Point Beach Nuclear Plant, Units 1 and 2
Dockets 50-266 and 50-301
Renewed License Nos. DPR-24 and DPR-27

License Amendment Request 261, Supplement 4
Extended Power Uprate

LICENSE AMENDMENT REQUEST 261, SUPPLEMENT 4 EXTENDED POWER UPRATE

Case 7-1: 2B-42 MCC Voltage Profile

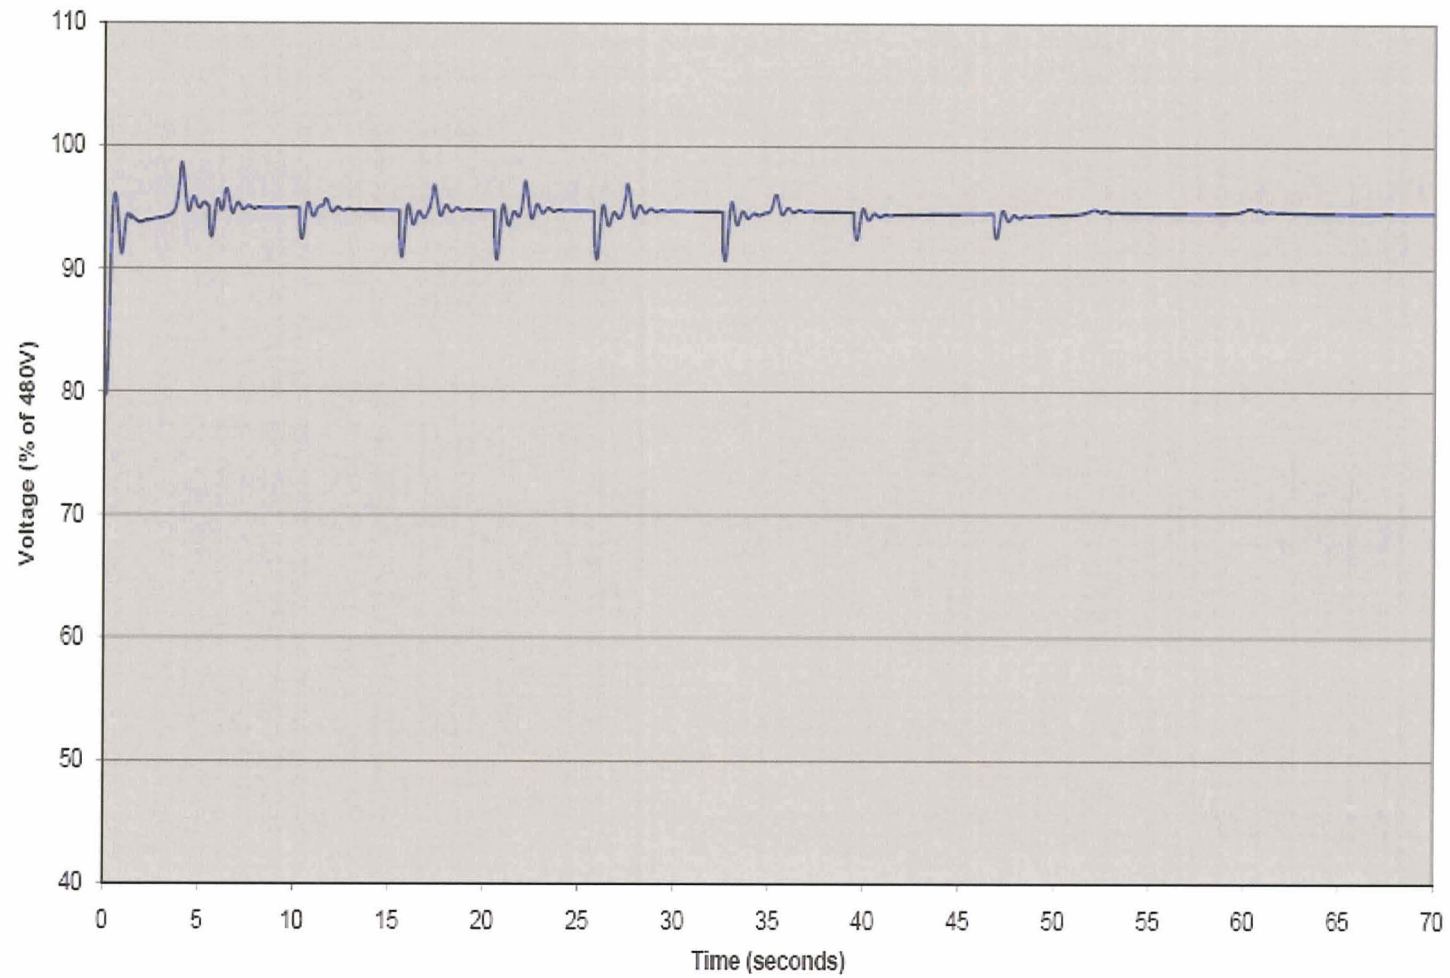
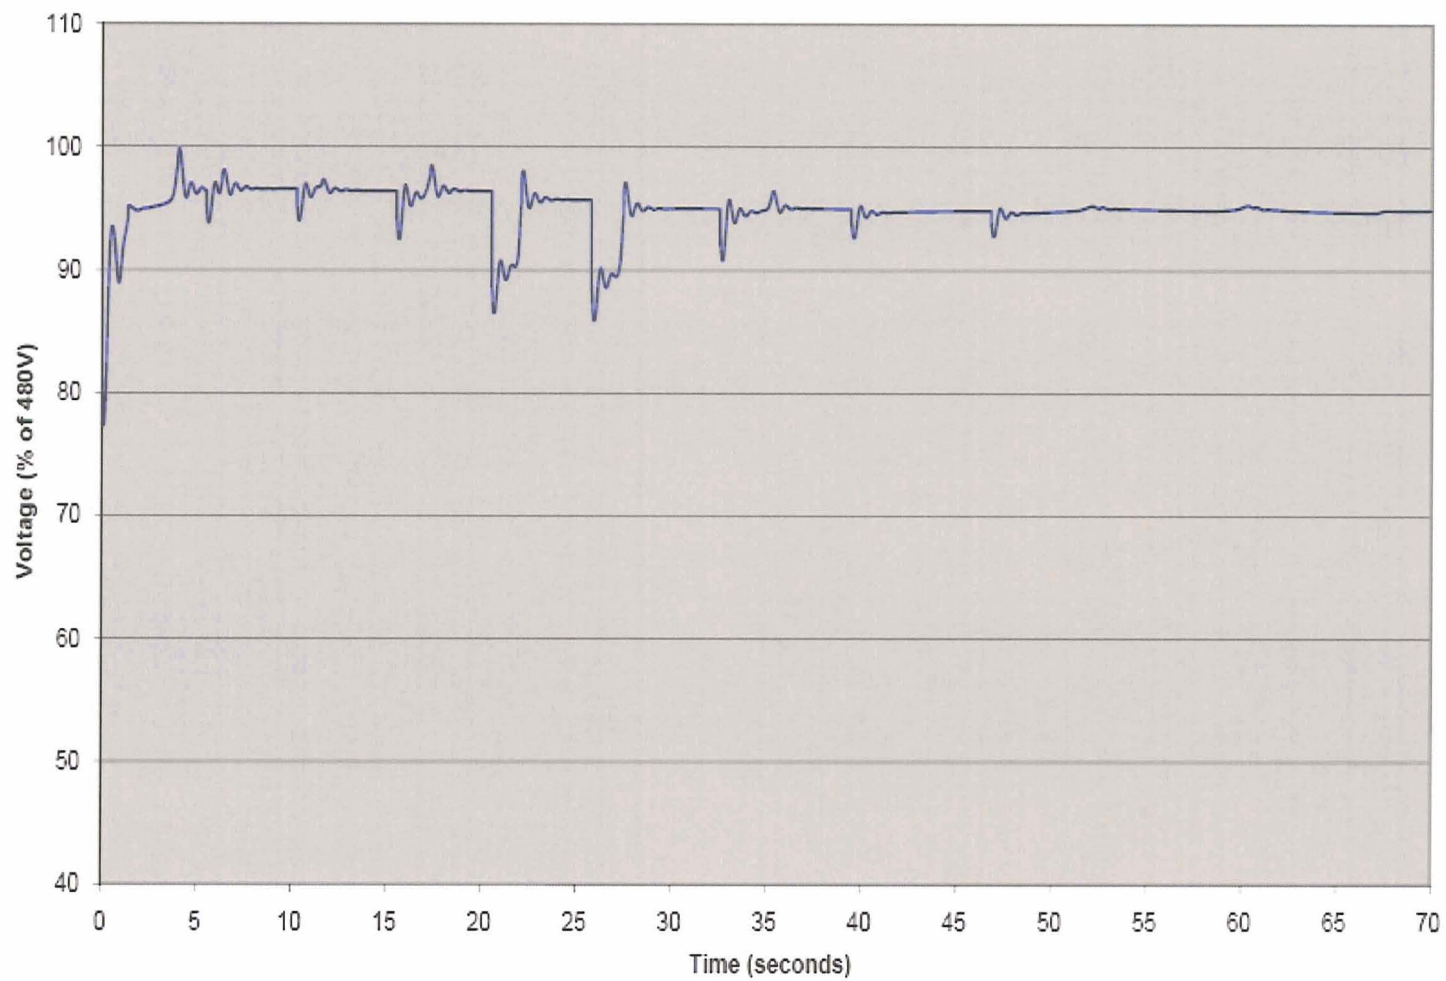
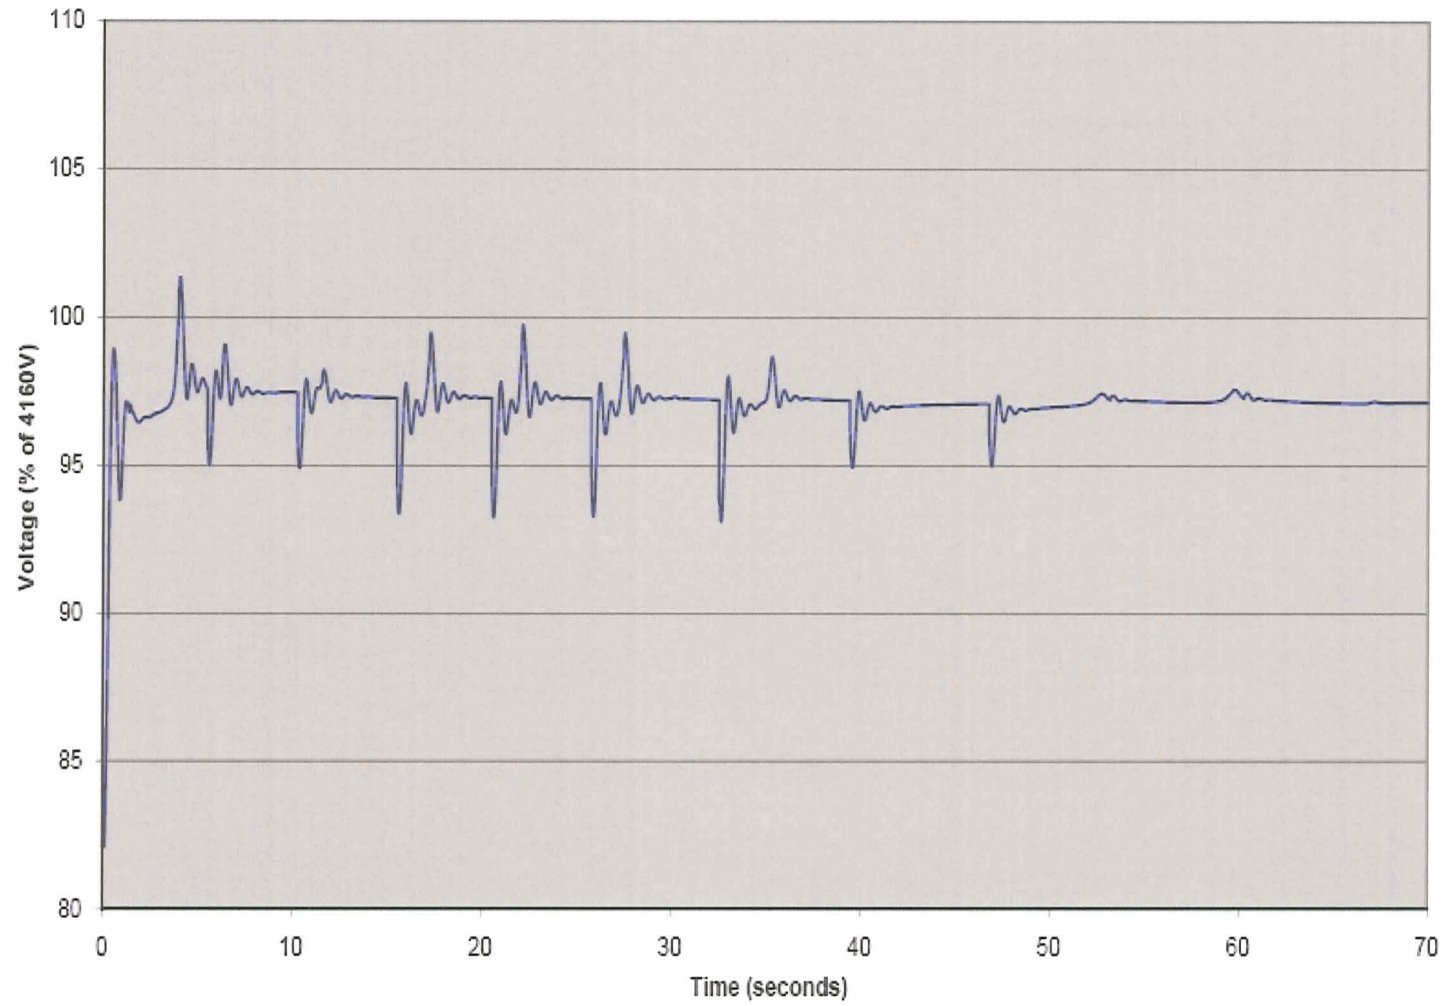
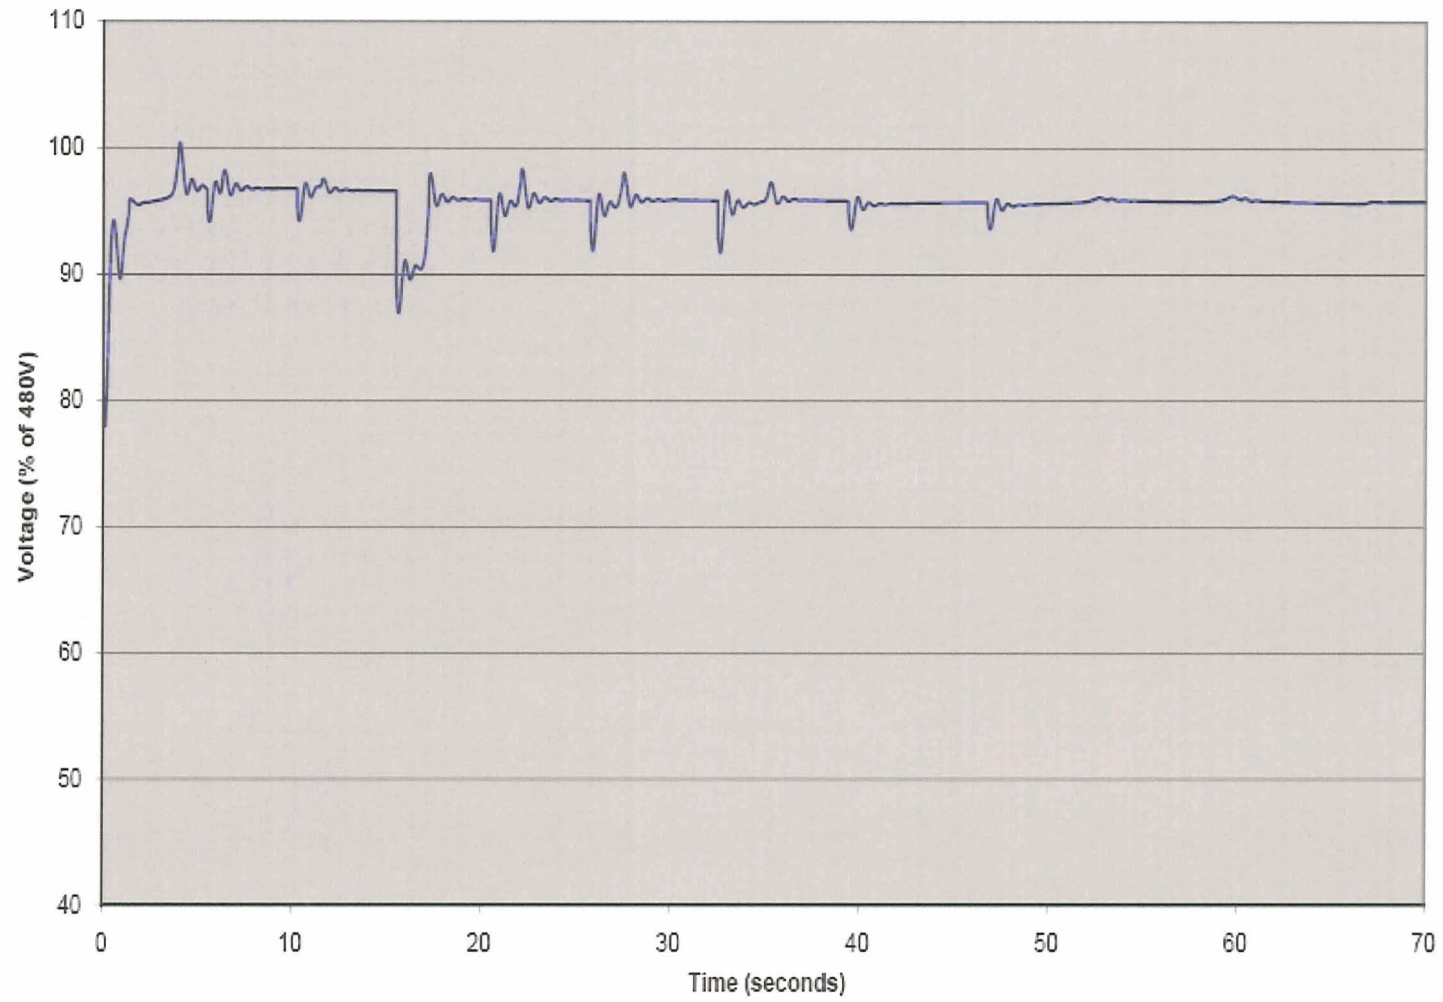
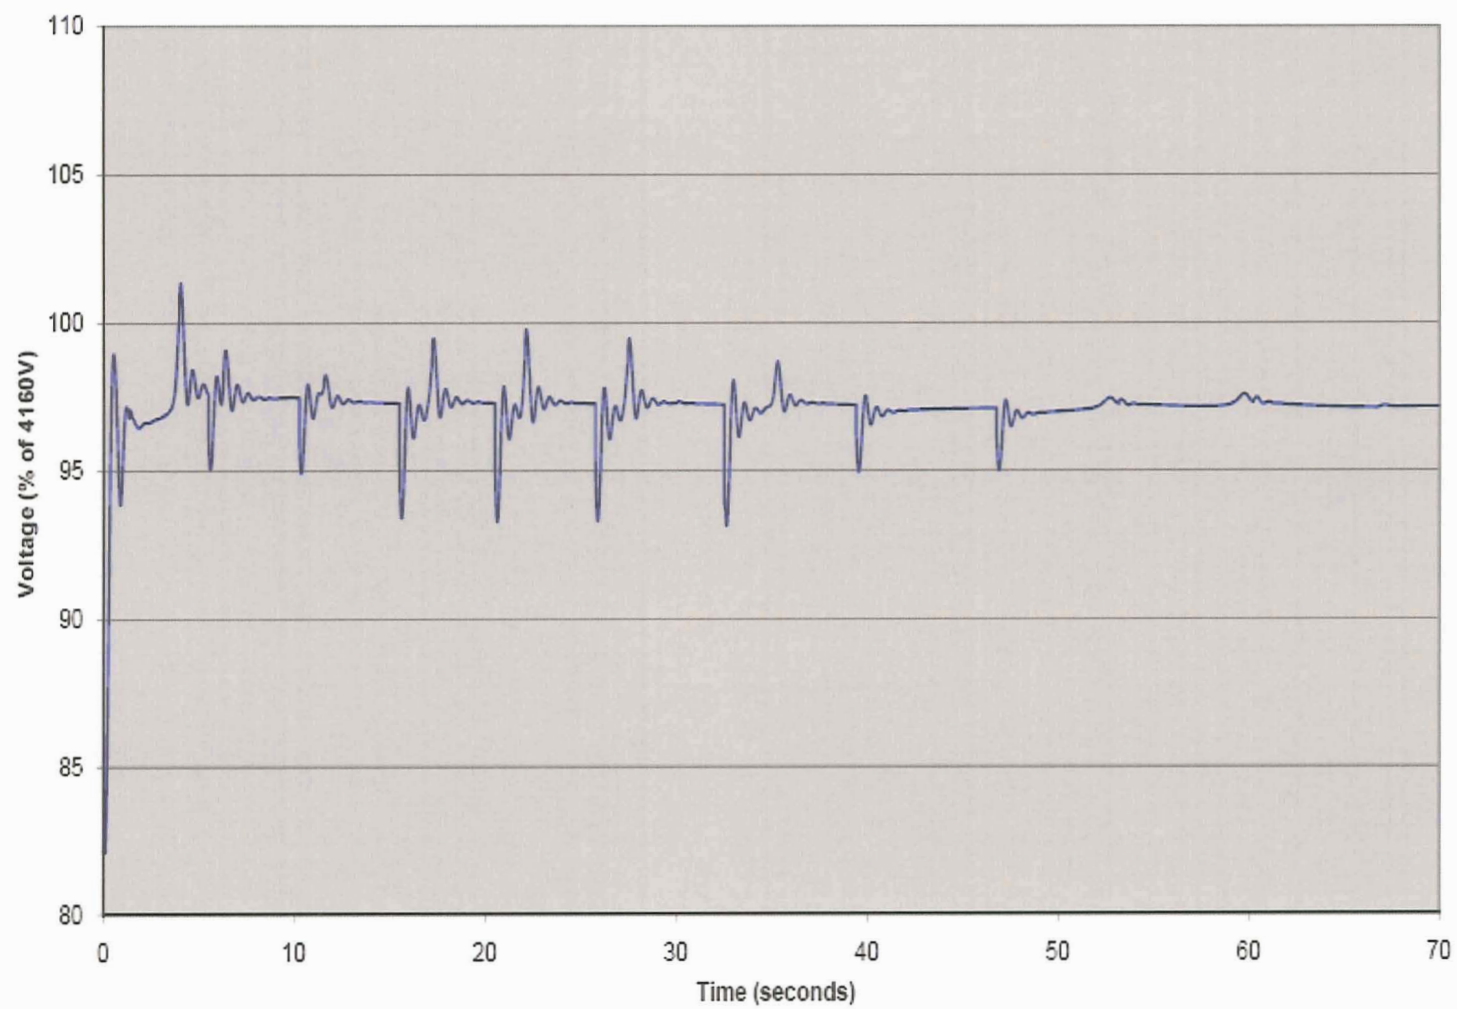
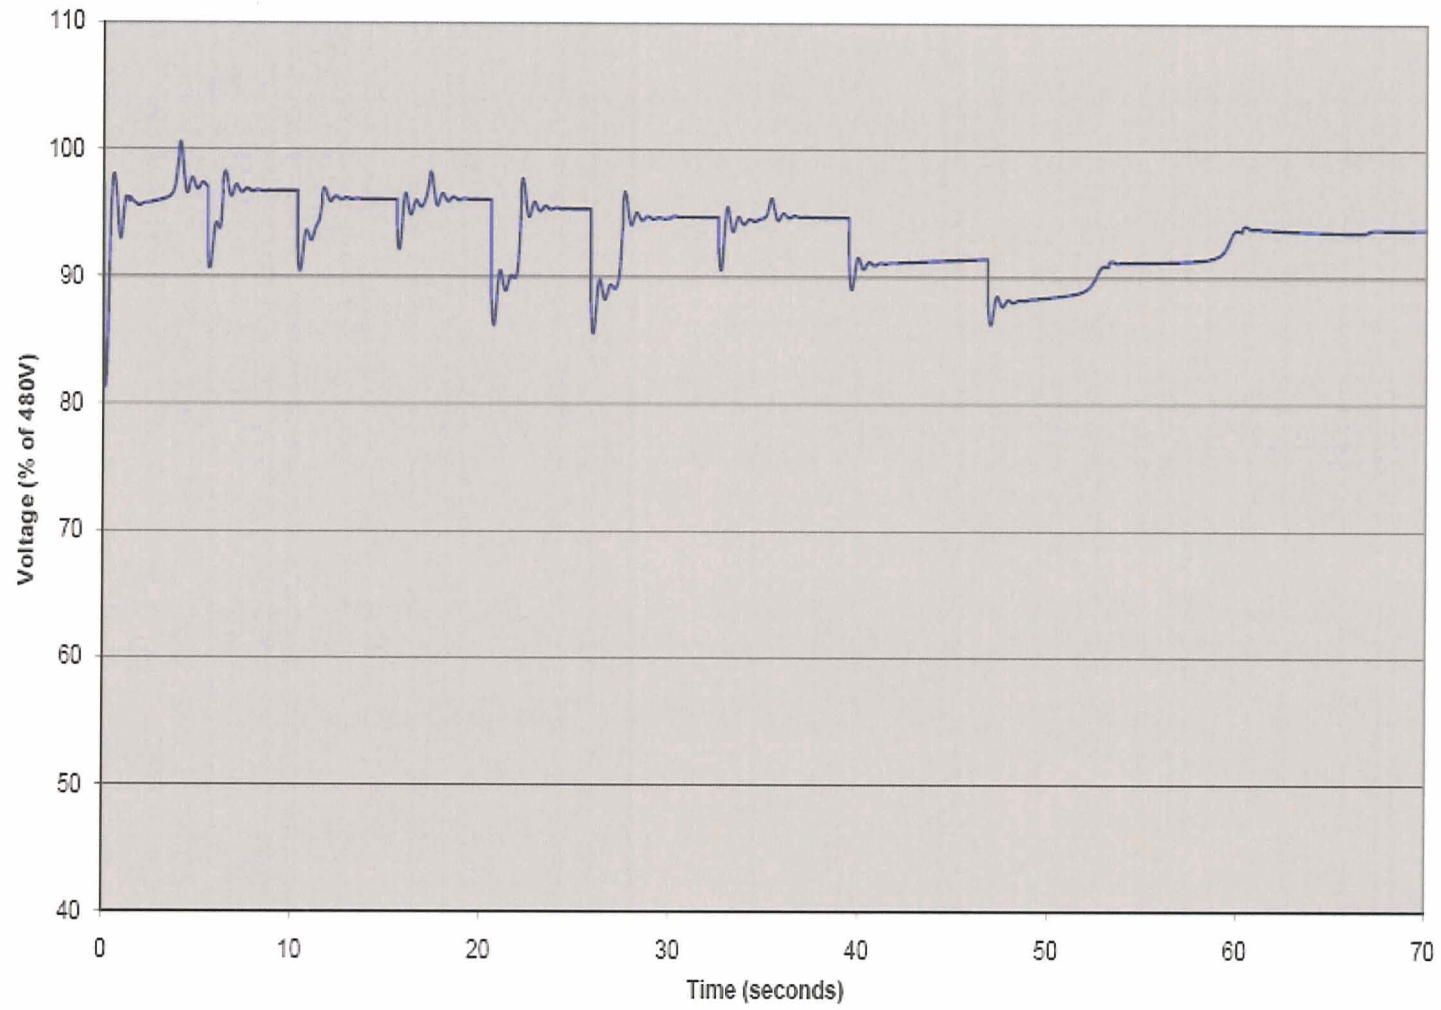
In response to staff's request for additional information (RAI) dated August 26, 2009, regarding the emergency diesel generator (EDG) voltage dip below the acceptance limit of 75 percent nominal voltage during motor start, the licensee stated that the EDGs are capable of starting safeguard loads, and the voltage recovers quickly to the acceptable level. Based on staff's review of the dynamic loading calculations, the staff notes that under certain loading conditions for Train "A" EDG, the frequency is outside 2 percent margin, the worst-case voltage dip is 45-48 percent and the voltage overshoot is 129.5 percent. Train "A" voltage and frequency variations are outside the industry accepted standards and guidance. Provide detailed analyses regarding the downstream effects on components such as contactors, control fuses, inverters, battery chargers, solenoids, motor-operated valves, solid state devices, etc., and the basis to show that all required loads will start and continue to run with sufficient margins after accounting for any uncertainties. Provide justification for the performance capabilities of the EDG "A" regulator and excitation systems to support shutdown equipment within design-basis requirements during a design-basis accident. The staff notes that Train "B" EDG bus voltages remain above 75 percent of nominal voltage, consistent with NRC Regulatory Guide (RG) 1.9, throughout the motor starting sequence in all postulated loading conditions. Provide a summary of all bus voltages for the 'B' train distribution system.

Attachment 5 provides a summary of bus voltages for the "B" train distribution system for the above large break LOCA design basis ETAP cases.
